Date July 27, 2018
Our reference n/a
Your reference n/a
Contact person S.P. Mulders
Telephone/fax +31 (0)6 5573 6149 / n/a
E-mail S.P.Mulders@TUDelft.nl
Subject Response to reviewers

Response to comments of Anonymous Referee #1

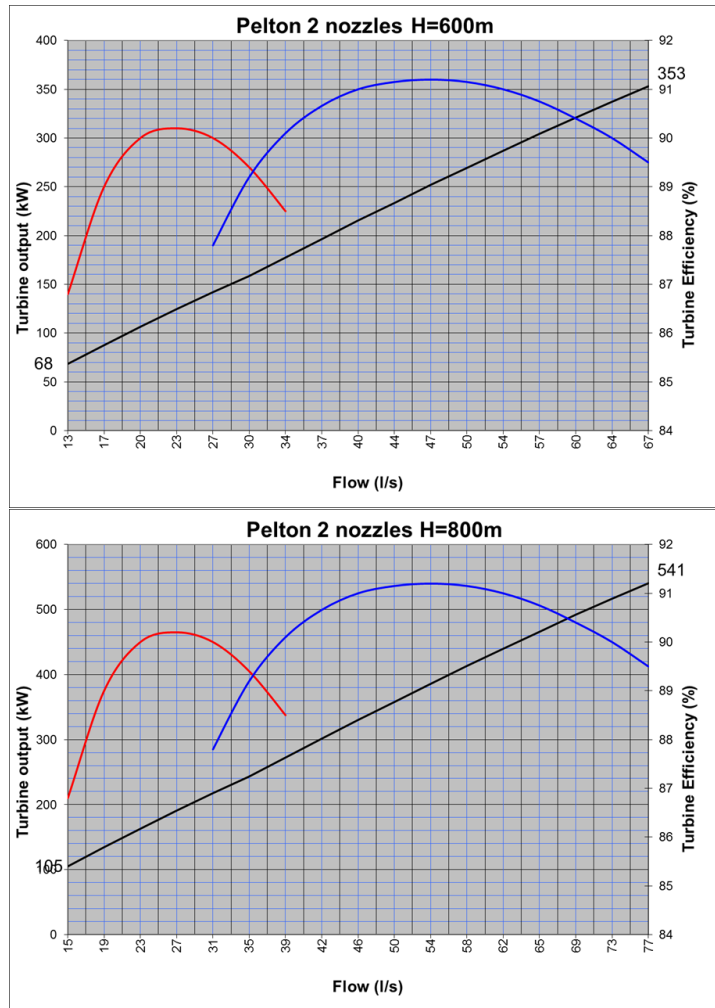
- Pelton Turbine. The concept of using a Pelton Turbine is very interesting. However, it seems that the Head [m] of this turbine is way above to the existing Pelton turbines, so that it might be impossible to borrow an existing design. What is the specific speed of the Pelton Turbine of this paper? Is a commercial Pelton wheel available? Is a two-jet turbine such as the one of fig. 5 sufficient? This is not the scope of this paper, however, the authors could be more clear on this part, perhaps using more references.

Thank you for raising this comment, we could have been more clear on this aspect. Pelton turbines are highly specialized pieces of equipment and need to be design for specific condition requirements [1]. The Sy Sima 315 MW turbine in Norway, for 88.5 bar of head pressure is to date the largest known [2]. The employed custom manufactured Pelton turbine for the DOT500 is designed to match the nominal pressure and the speed conditions of the connected electrical generator.

A custom-made Pelton turbine is designed such that the efficiency is optimal under the expected operational conditions. For this, the turbine is designed for optimal operation using 2 spear valves, subject to a nominal flow of 58 l/min. Graphs of the turbine manufacturer (given below) show that the efficiency is primarily a function of the supplied flow, and to a lesser extent of the head. The red line indicates operation with 1 spear valve, the blue line 2 spear valves.

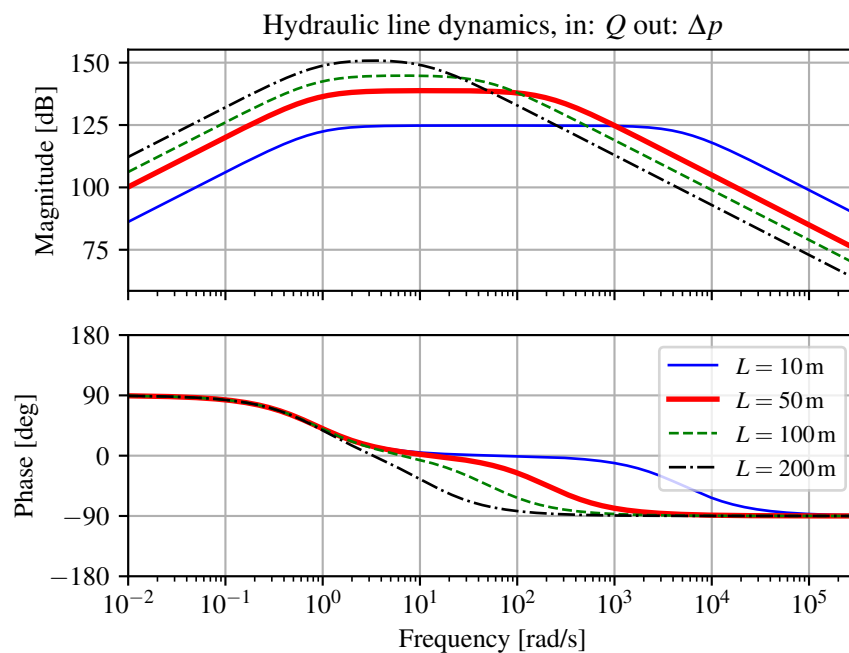
1. Is there provided, or could the authors provide, a quick impression of how the efficiency of the proposed system, in total, would compare to a similar conventional system? For example, given the same rotors, what would a standard efficiency to final electrical power be (90%?) and what would it be for this system?

For the described DOT prototype, the total power transmission efficiency was predictably low, as a result of the double hydraulic circuit. In the below-rated region an efficiency is attained of 30 – 45 % depending on the operating conditions, whereas in the above-rated region a consistent drivetrain efficiency of 45 % is attained. As described in the manuscript, off-the-shelf components are used, of which the optimal efficiency operational envelopes do not match. The drivetrain has a fixed-volumetric displacement, which means that the pressure and flow changes according to the turbine operating conditions. Figure 13 shows that drivetrain components have a specific region in which they yield maximum efficiency.

The above given reasoning holds for the described prototype. It is however yet unclear what the drivetrain efficiency of the final DOT concept will be, as the seawater pump is still under development. An earlier PhD thesis on hydraulic wind turbine networks [7] provides an estimate on the overall conversion efficiency of conventional and hydraulic wind turbines of 82 – 84 % and 70 – 80 %, respectively.

The efficiency numbers attained with the intermediate DOT500 prototype are added to Section 2.1.

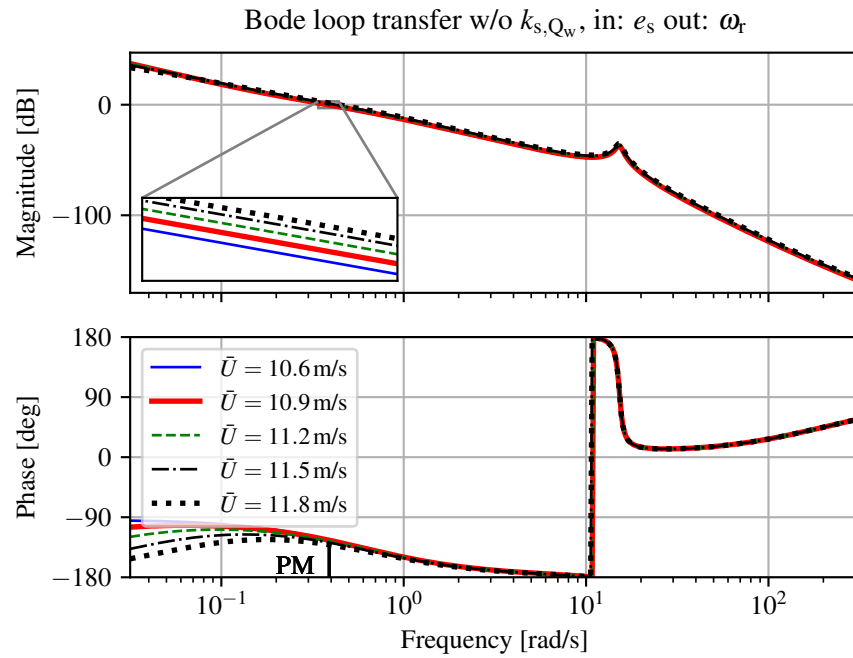
7. Fig 18: The legend is hard to understand, why the lower-case bold "without" following the period? Since the phase margin is discussed later, could it be indicated in this figure?

Thank you for pointing out this mistake, the point should be a comma. The suggestion of indicating the phase margin is taken, and both bode plots are updated.

Also, again, the upload process changed the figure, by omitting some symbols. The correct figure is shown below for reference.

The mistake in the caption is fixed, and the Bode plots include an indication of the phase margin (PM).
